STATE OF HAWAII
DEPARTMENT OF TRANSPORTATION
HIGHWAYS DIVISION

INTERSTATE ROUTE H-1
ADDITION AND MODIFICATION OF FREEWAY ACCESS
(Kapolei Interchange Complex), Phase 2
Federal-Aid Project No. IM-HI-1 (261)

SHEET No. SI-1 OF 103 SHEETS

STAGE 5
Not to Scale

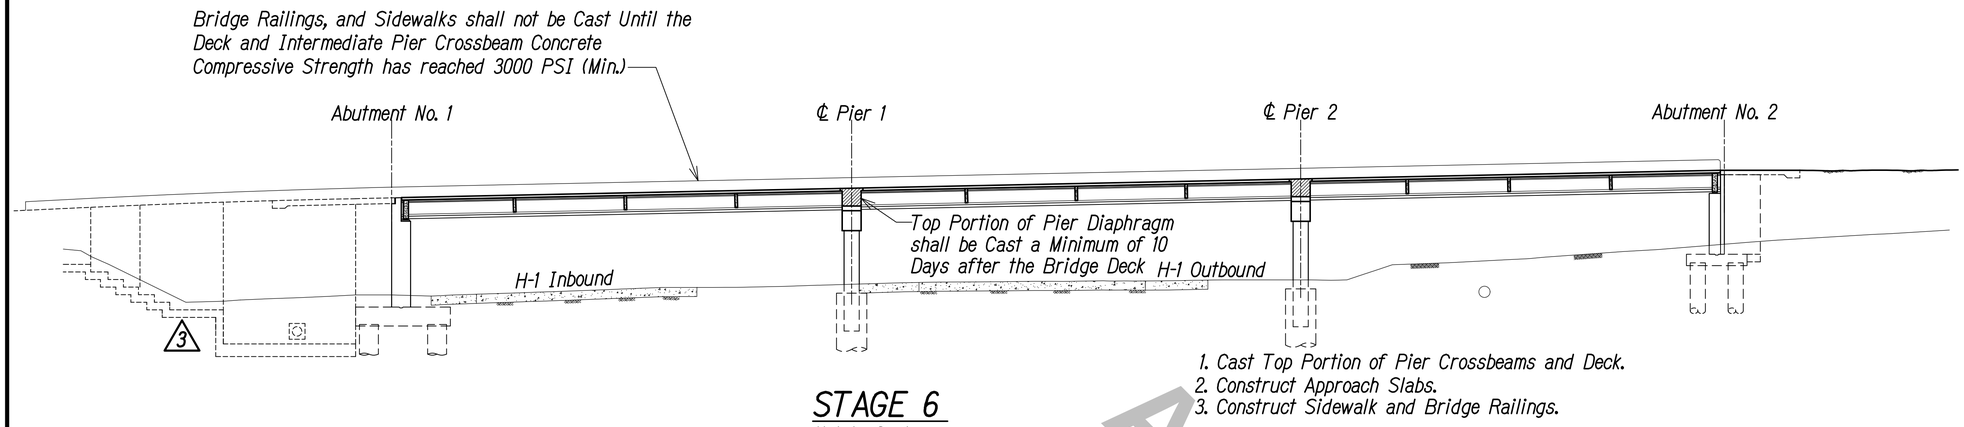
See RFI 074 Response dated 9.23.2016

SHAFT CAP PLAN (ABUTMENT No. 1)

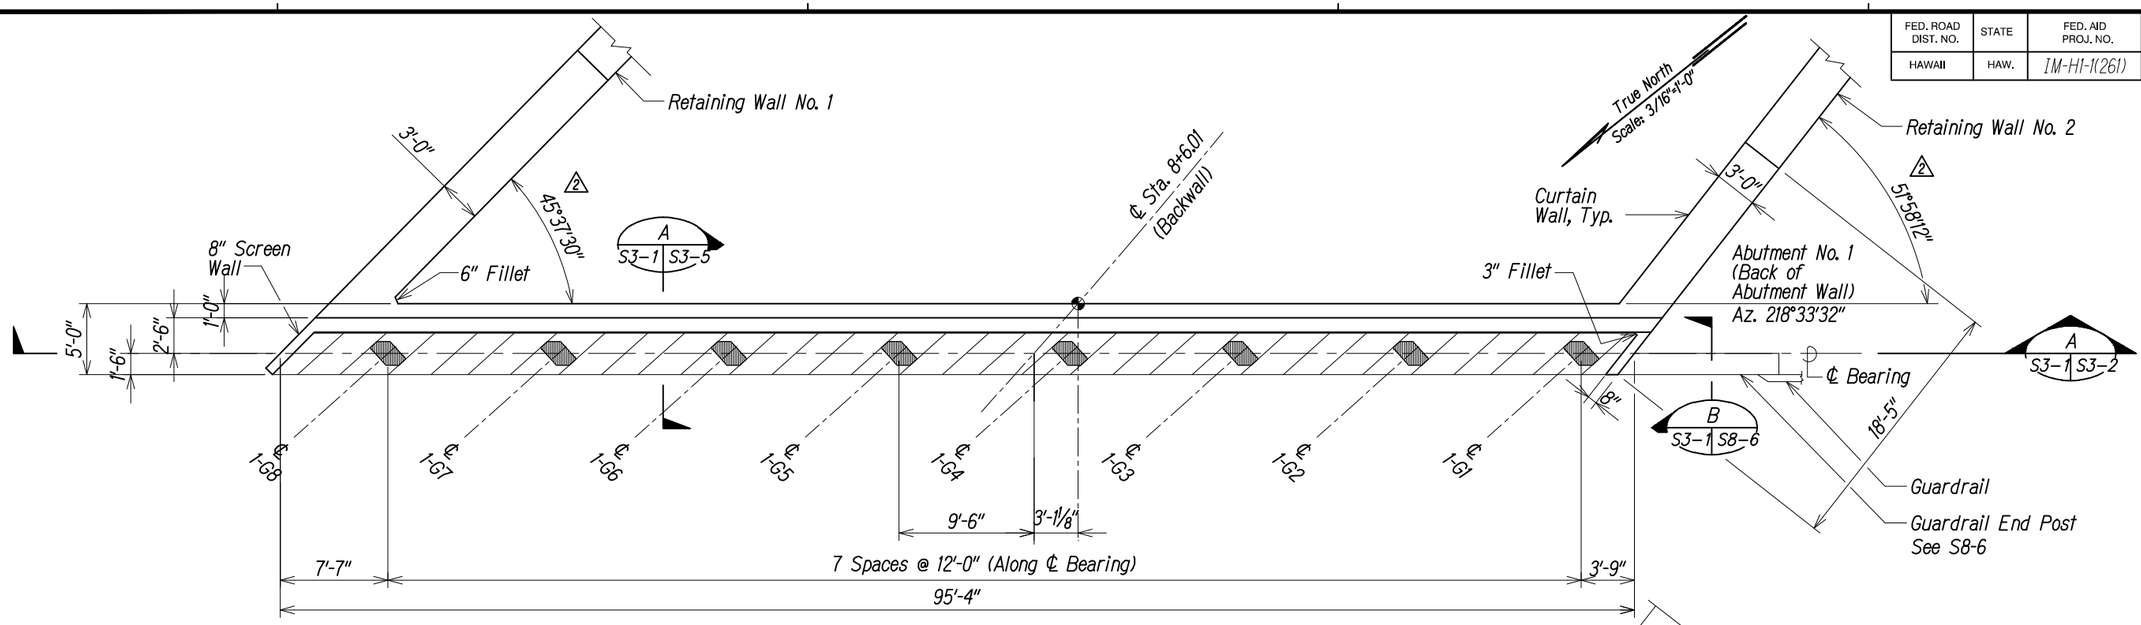
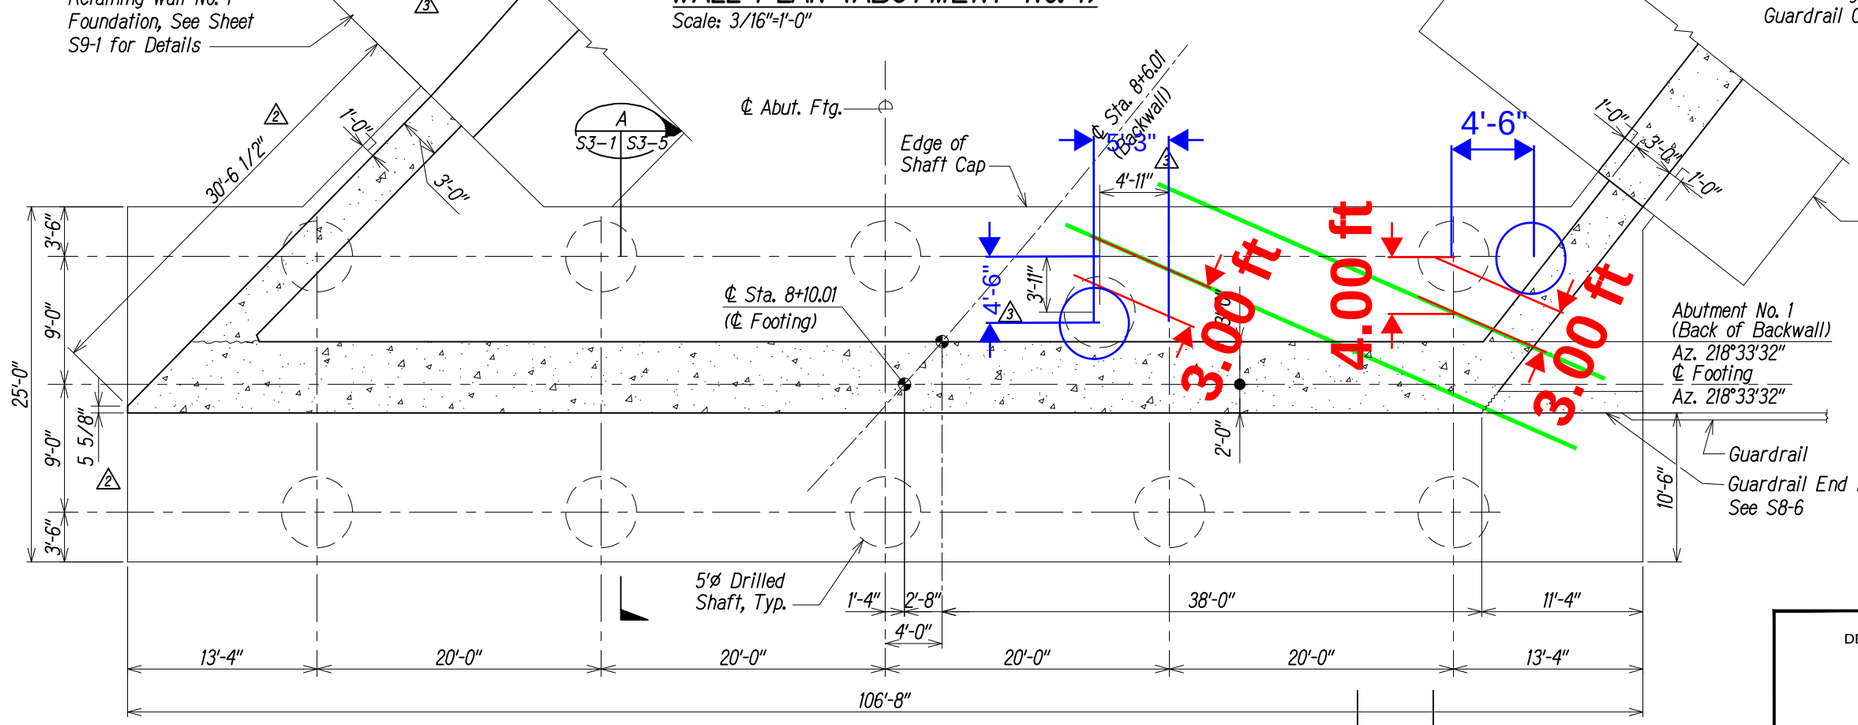
RFI 211

ROADWAY EXPANSION JOINT AT ABUTMENTS
Scale: 1/2"=1'-0"

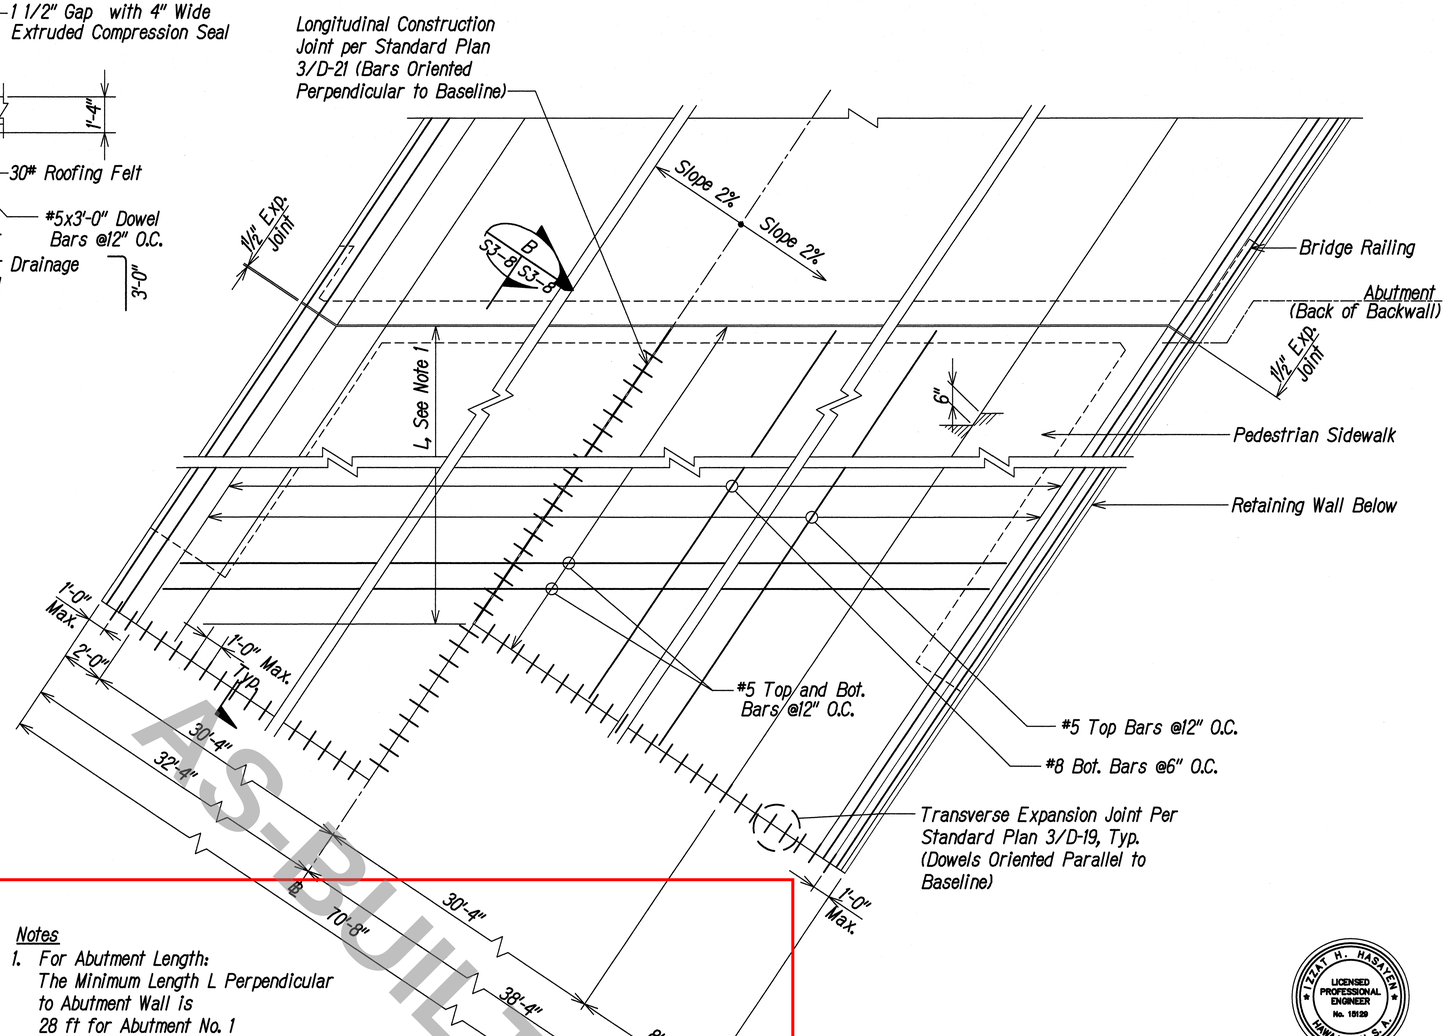
Omit 2" Styrofoam per RFI 190

PIER CAP PLAN - PIER No. 2

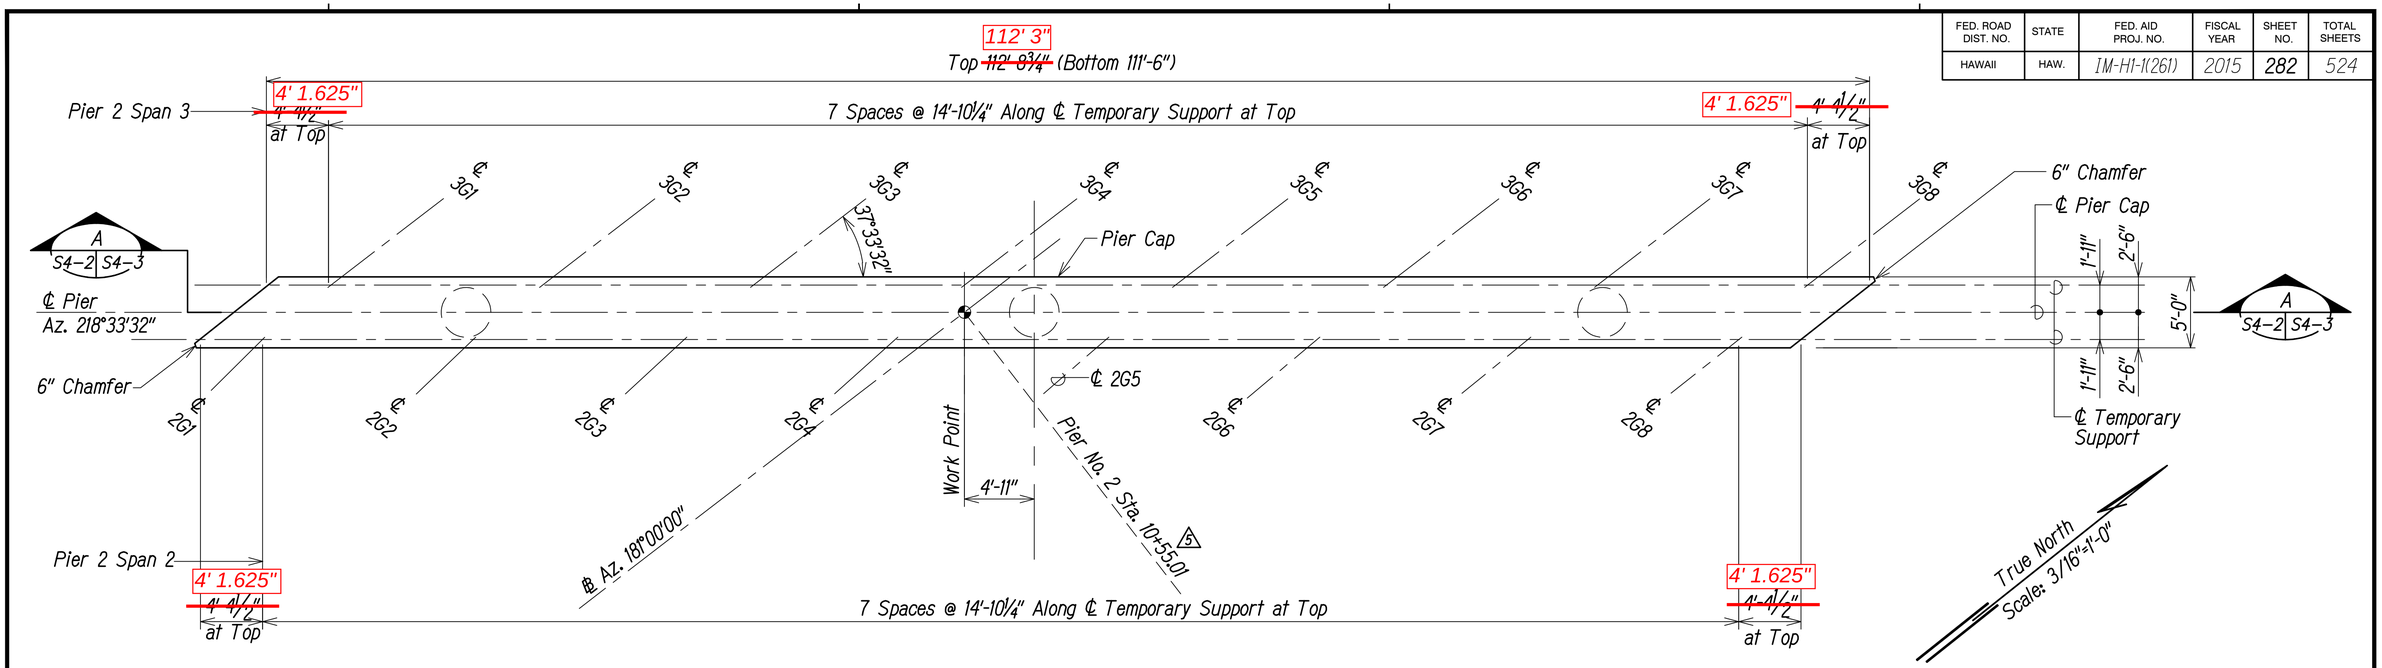
DIMENSION REVISED BY RFI 148

5 PIER No. 1 BARRIER - PLAN (A S4-7 | S4-7)
Not To Scale

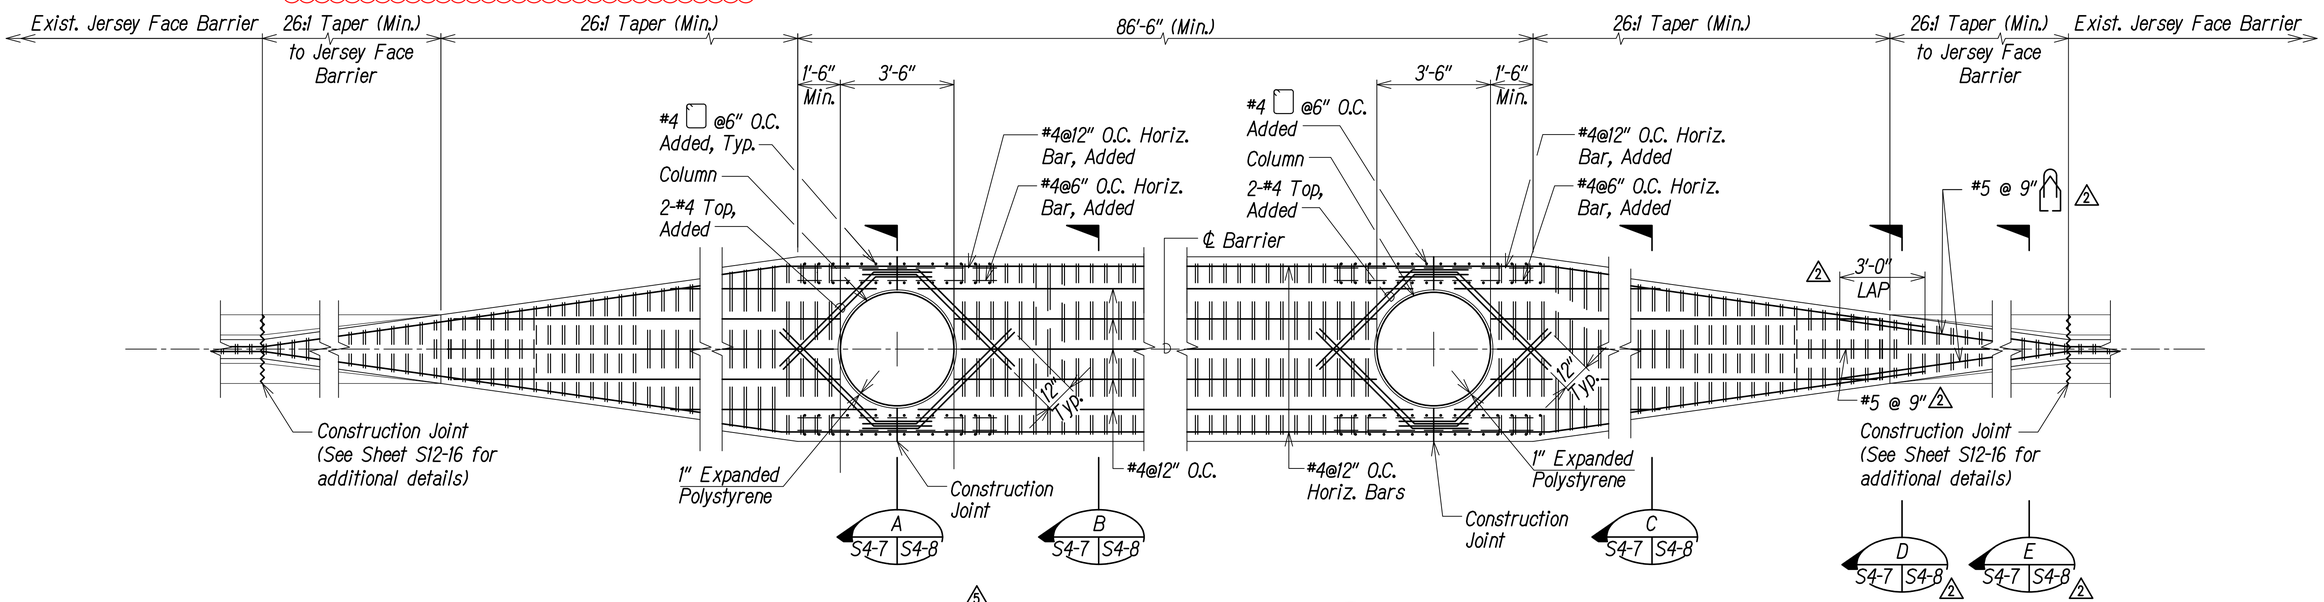
See RFI 209 Response dated 7/27/18

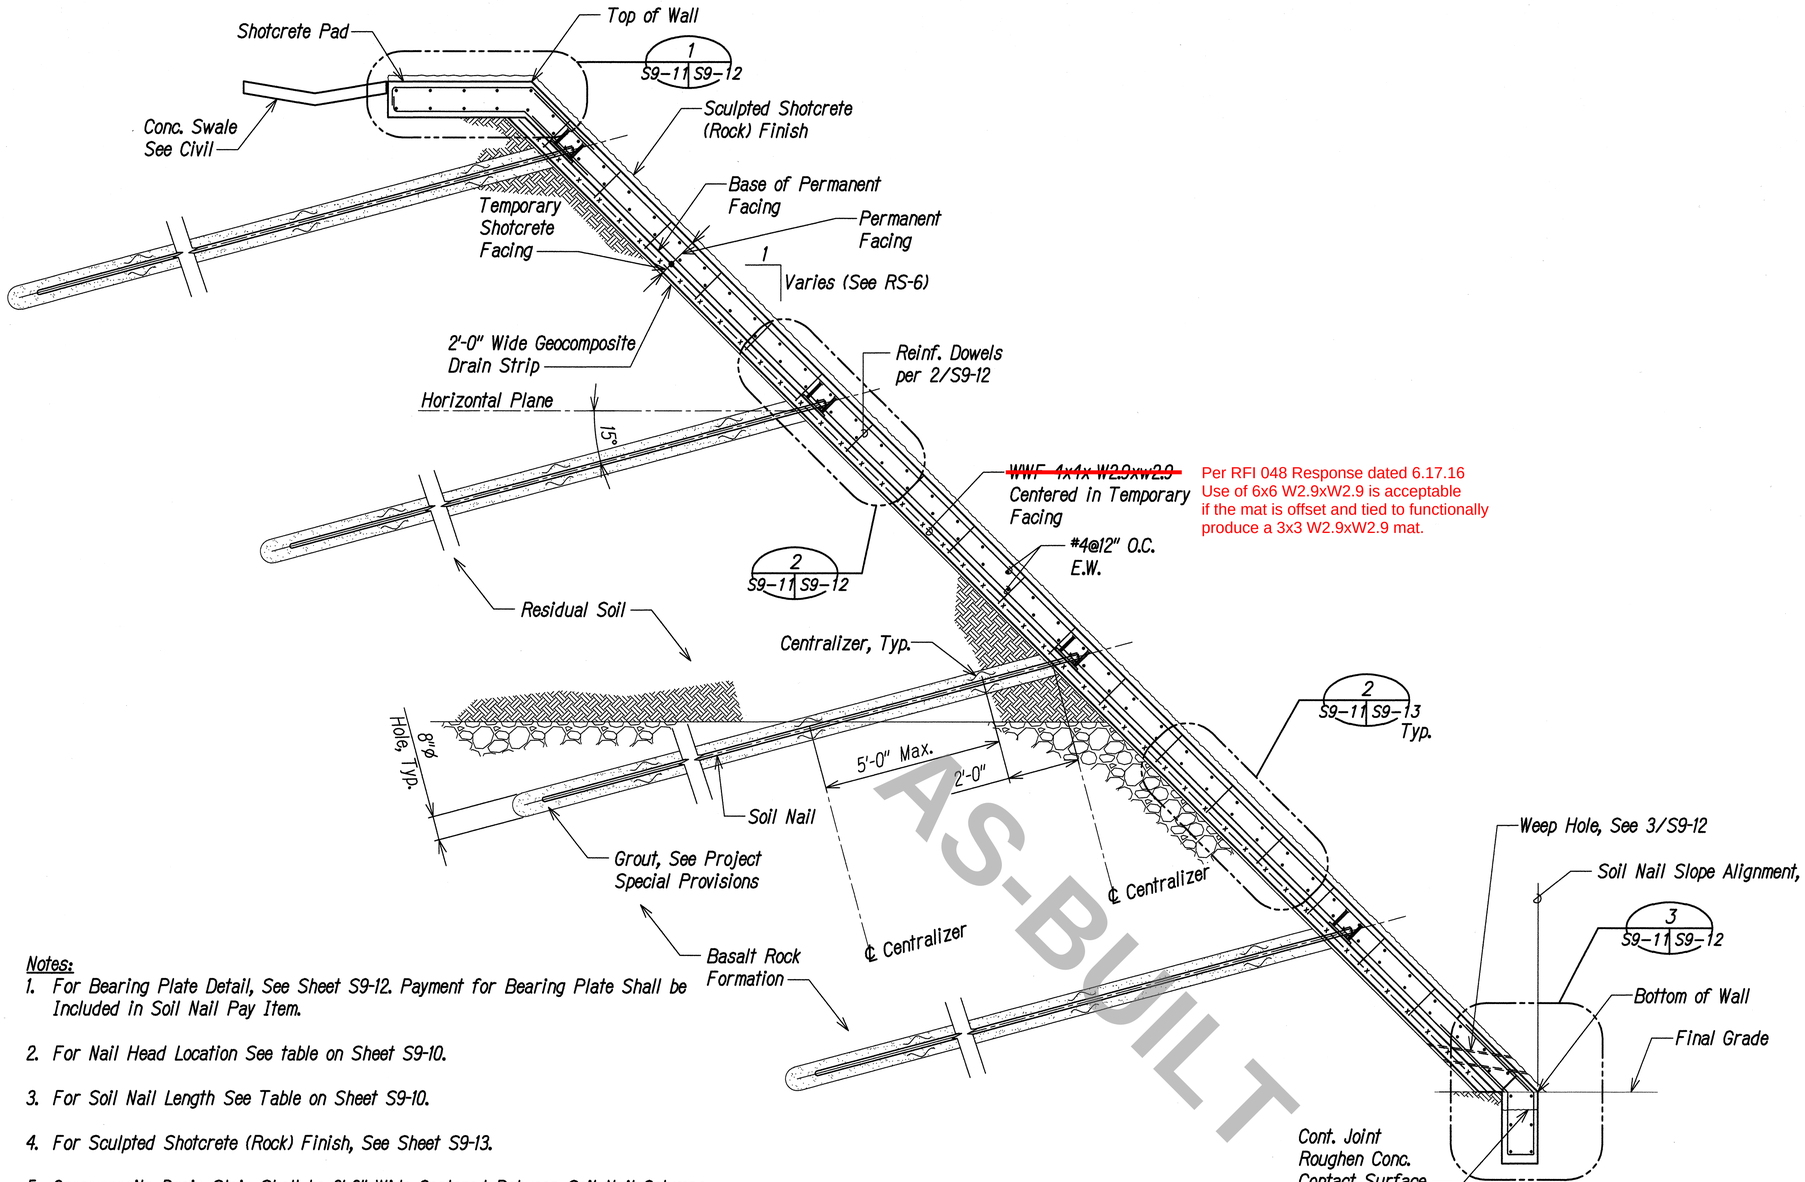
Per RFI 048 Response dated 6.17.16
Use of 6x6 W2.9xW2.9 is acceptable
if the mat is offset and tied to functionally
produce a 3x3 W2.9xW2.9 mat.
